Addendum 3 for RFB927940-04

Project Name: WRC Decentralization Phase 4 & Fire Alarm Phase 3 (9279.40 & 9279.41) Bid Issuance #4
DAS RFB #: 927940-04
DAS Project #: 9279.40 & 9279.41
Date: 6/2/2026

**FIRST FLOOR
FIRE
PROTECTION
PLAN**
09-FP101

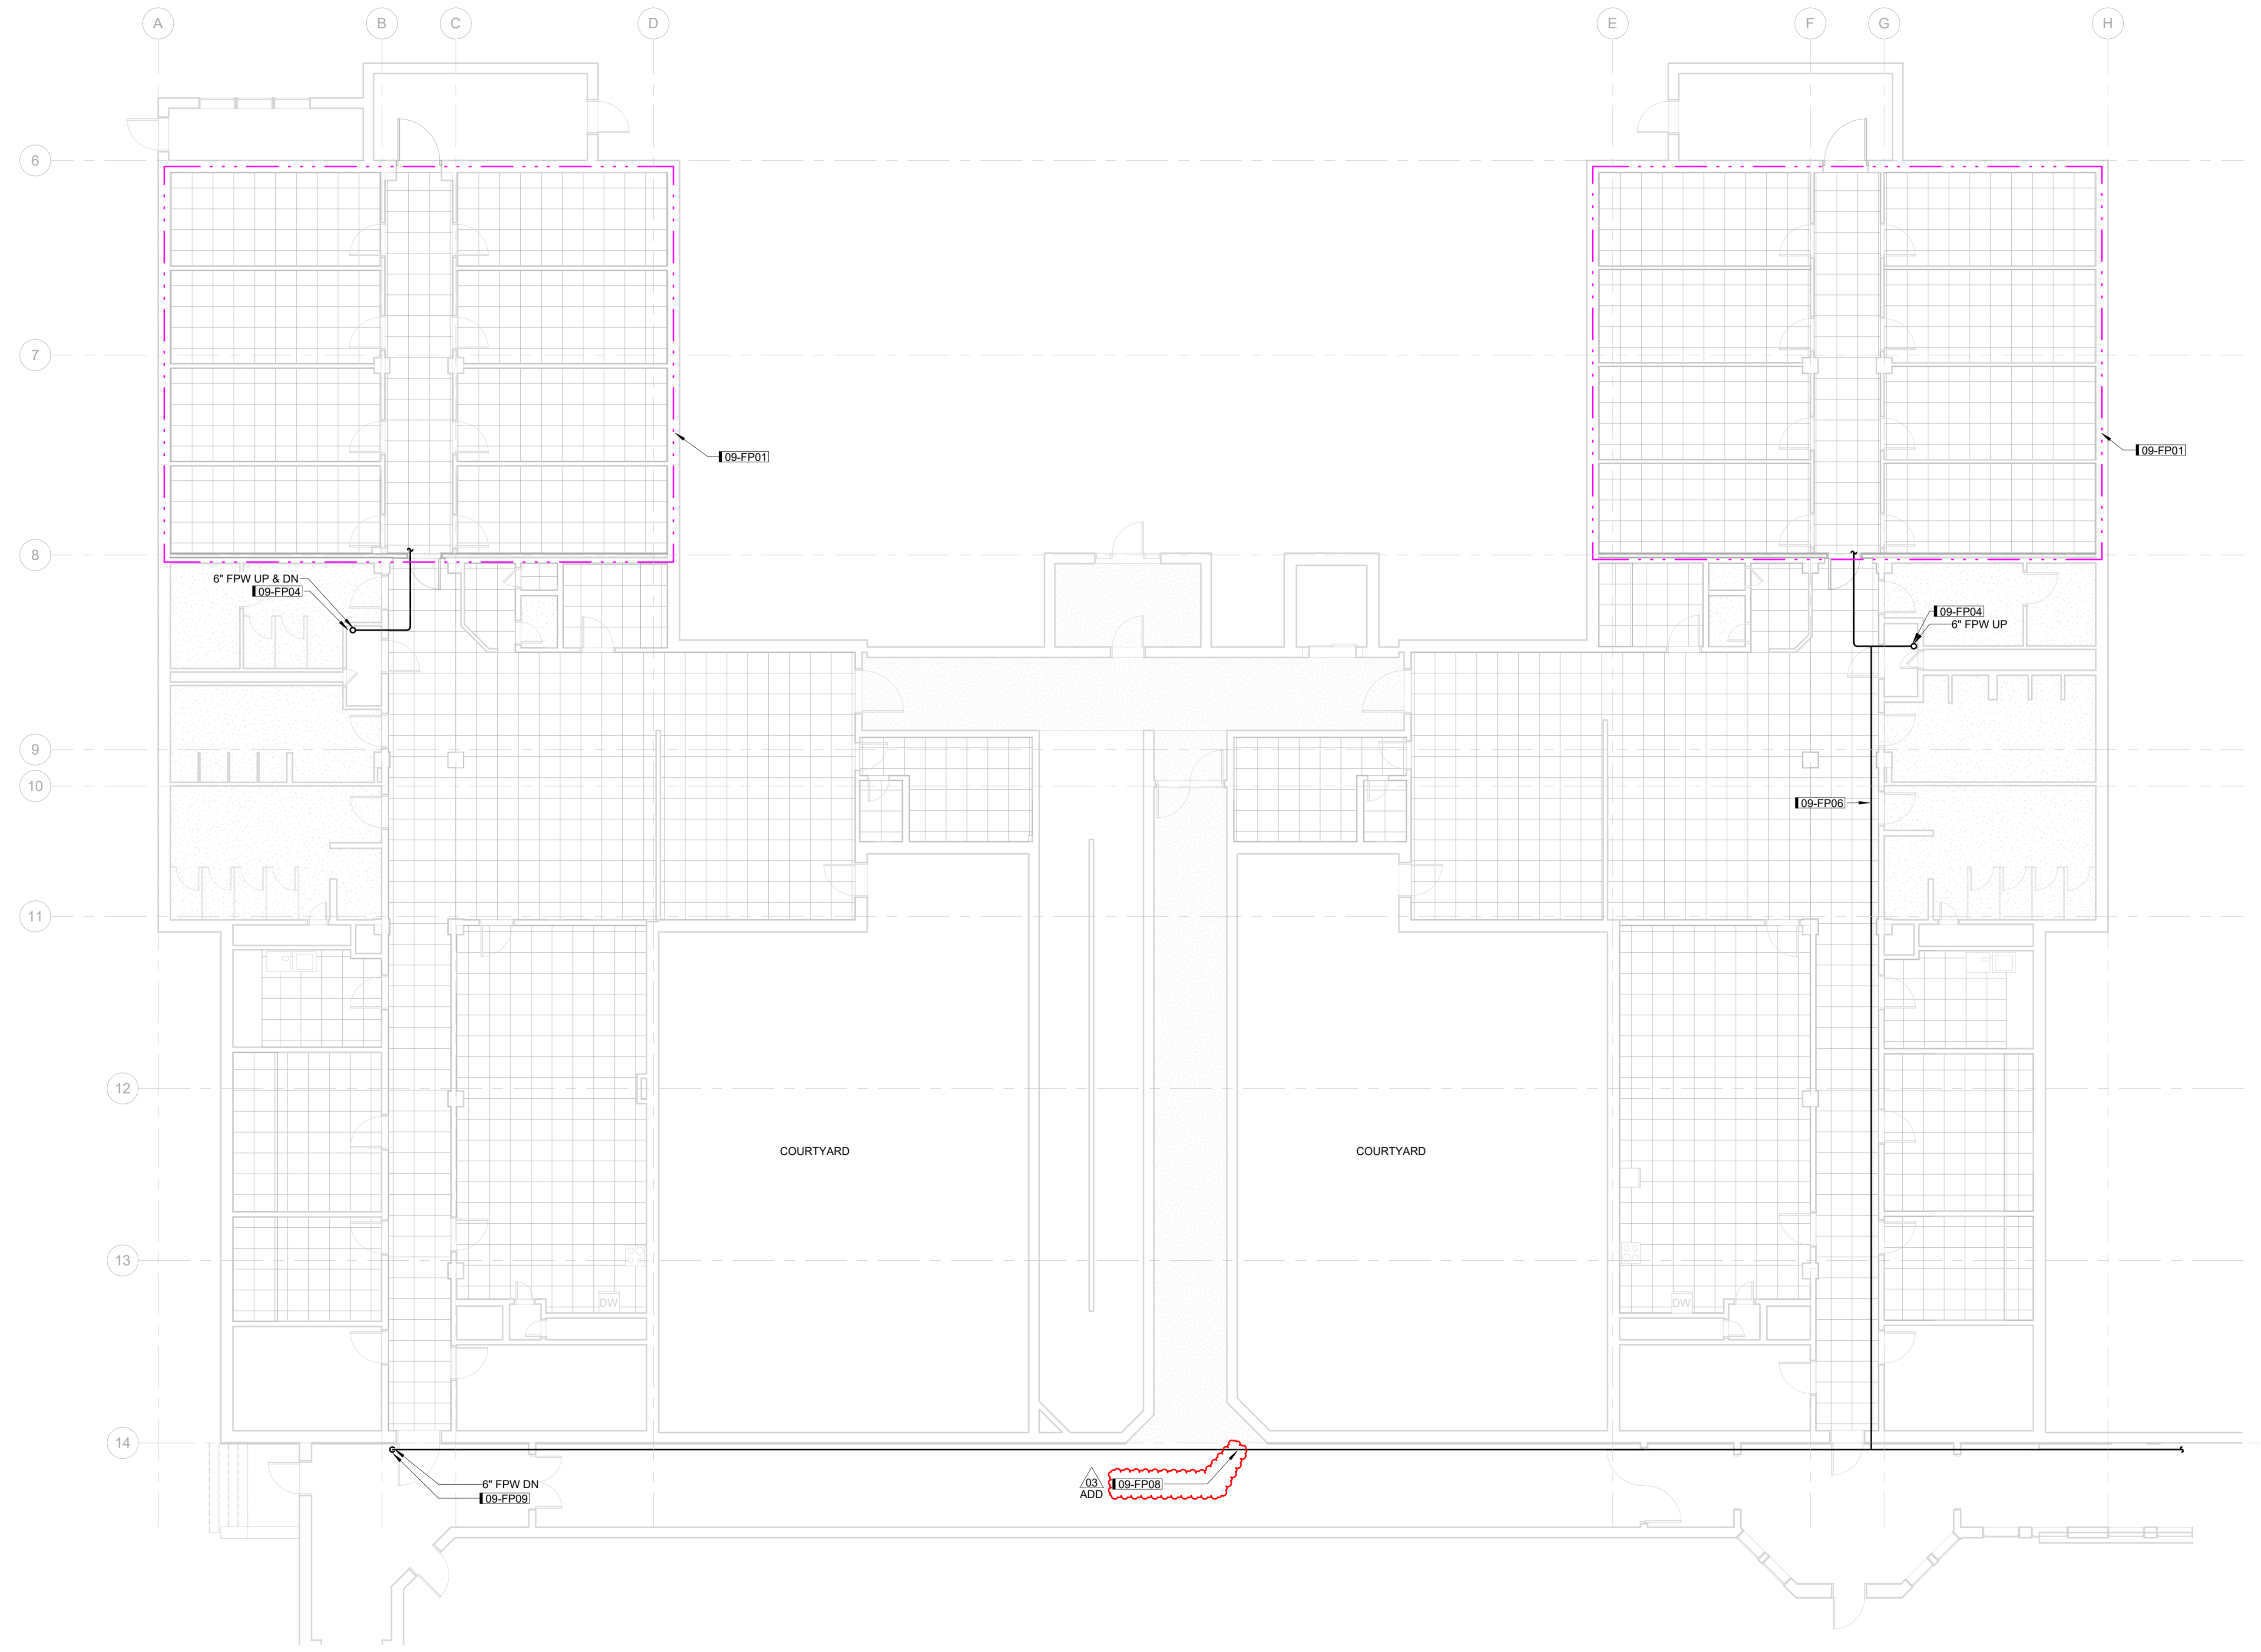
- **09-FP101 – FIRST FLOOR FIRE PROTECTION PLAN:**
 - **ADD** Keynote 09-FP08 to fire protection piping in corridor.

09-M400

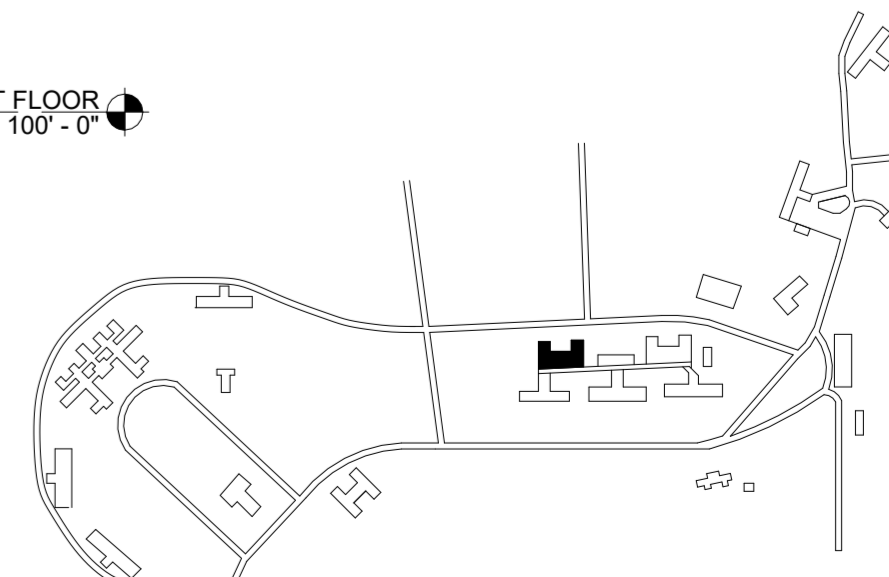
- **09-M400 – BUILDING A & B ENLARGED AHU PLANS:**
 - **ADD** Approximate duct support locations to exterior ductwork and associated note “SUPPORTS REPRESENTATIVE OF APPROXIMATE REQUIRED SUPPORTING DISTANCE REQUIREMENTS AND QUANTITY. CONTRACTOR SHALL VERIFY SUPPORTING REQUIREMENTS WITH FINAL DUCT SIZES AND SMACNA GUIDELINES. CONTRACTOR SHALL COORDINATE LOCATIONS OF SUPPORTS WITH ALL UNDERGROUND UTILITIES AND VERIFY ALL EXISTING CONDITIONS PRIOR TO EXCAVATION AND CONSTRUCTION.”

SUPPORTS REPRESENTATIVE OF APPROXIMATE REQUIRED SUPPORTING DISTANCE REQUIREMENTS AND QUANTITY. CONTRACTOR SHALL VERIFY SUPPORTING REQUIREMENTS WITH FINAL DUCT SIZES AND SMACNA GUIDELINES. CONTRACTOR SHALL COORDINATE LOCATIONS OF SUPPORTS WITH ALL UNDERGROUND UTILITIES AND VERIFY ALL EXISTING CONDITIONS PRIOR TO EXCAVATION AND CONSTRUCTION.

09-M402

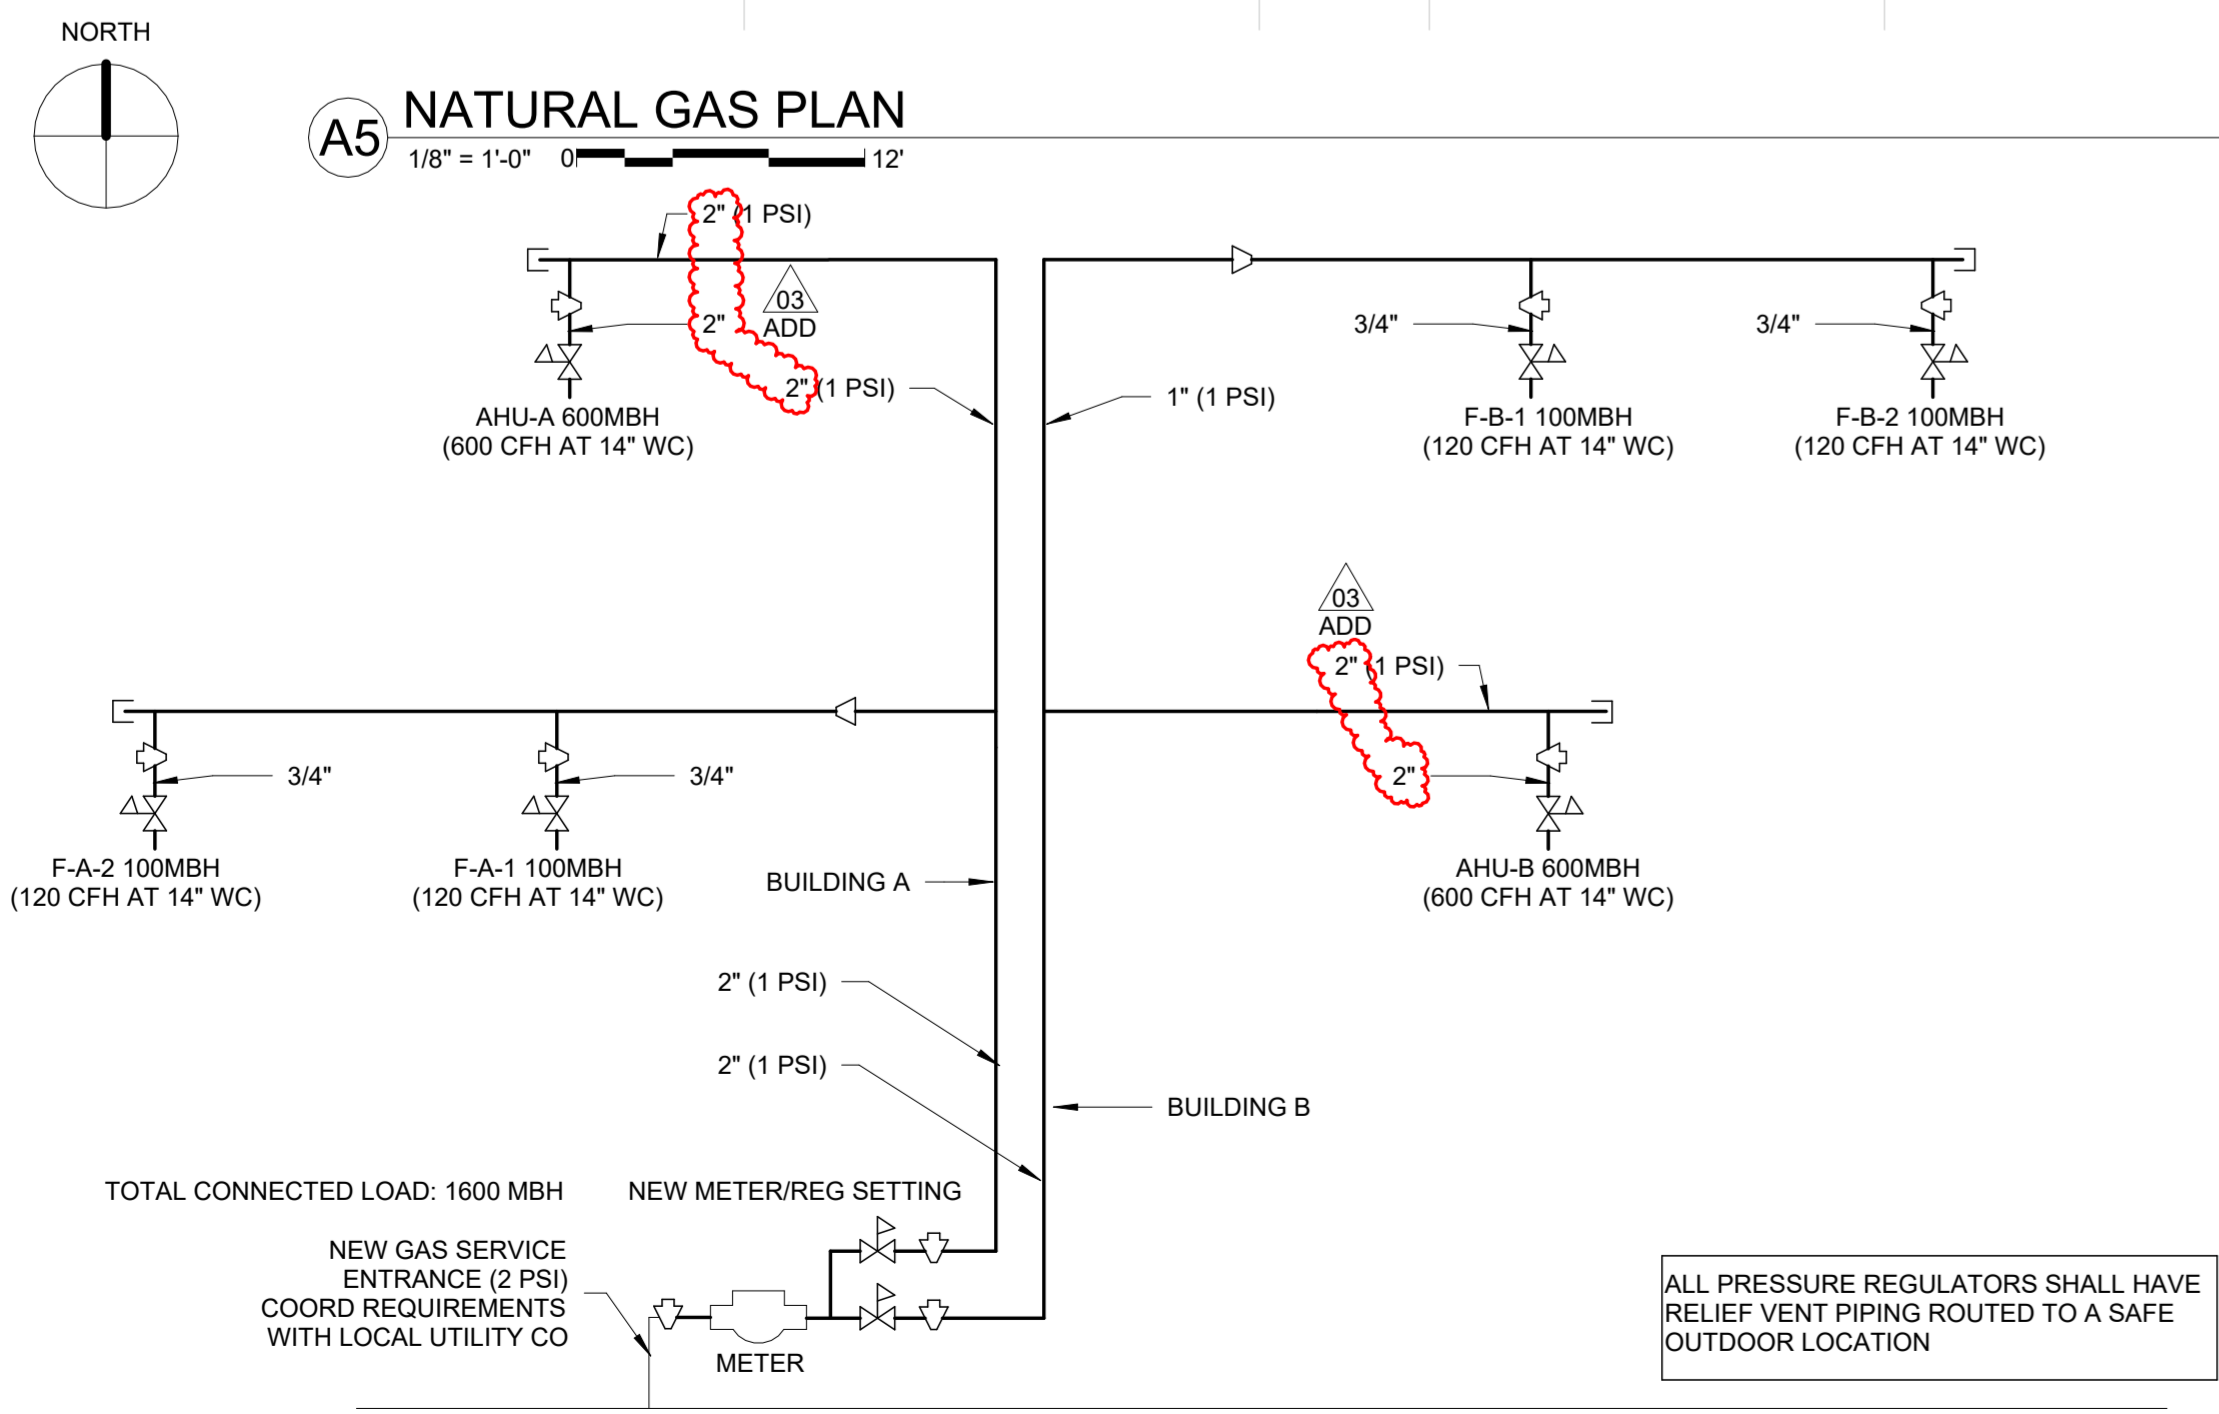
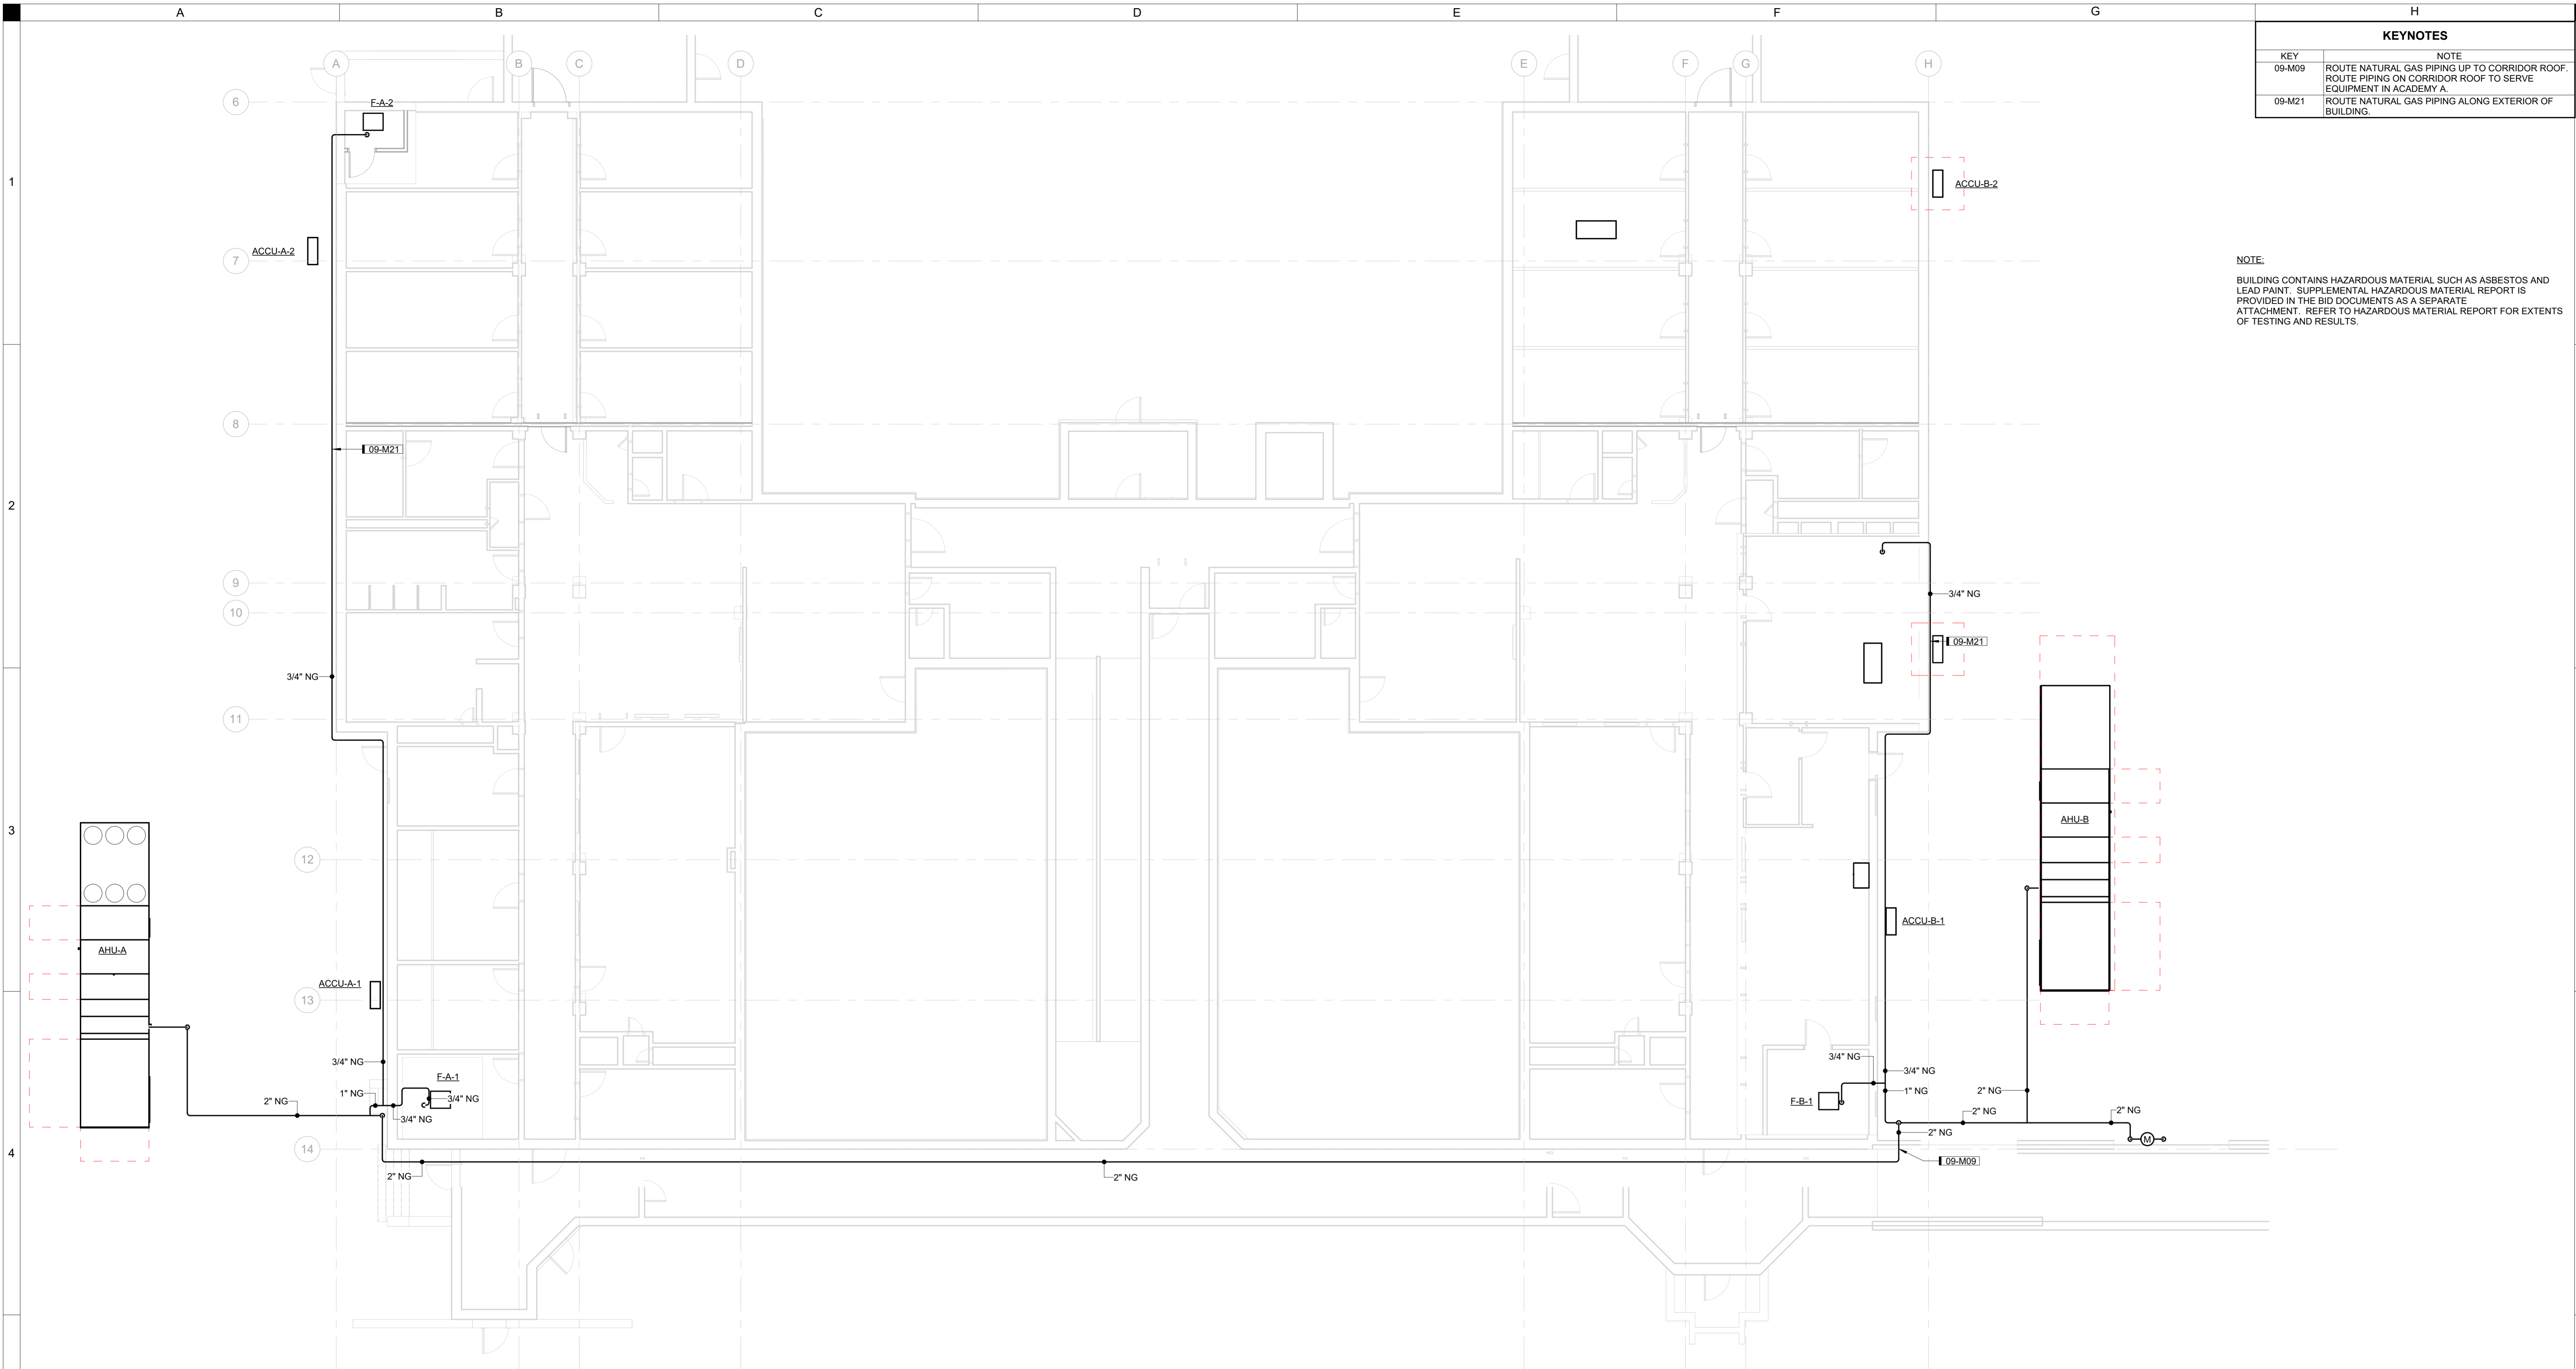
- **09-M402 – BUILDING A & B NATURAL GAS PLAN:**
 - **REVISE** Natural gas pipe sizing to AHU-A and AHU-B on Gas Piping Schematic.
- **09-M600 – MECHANICAL SCHEDULES:**
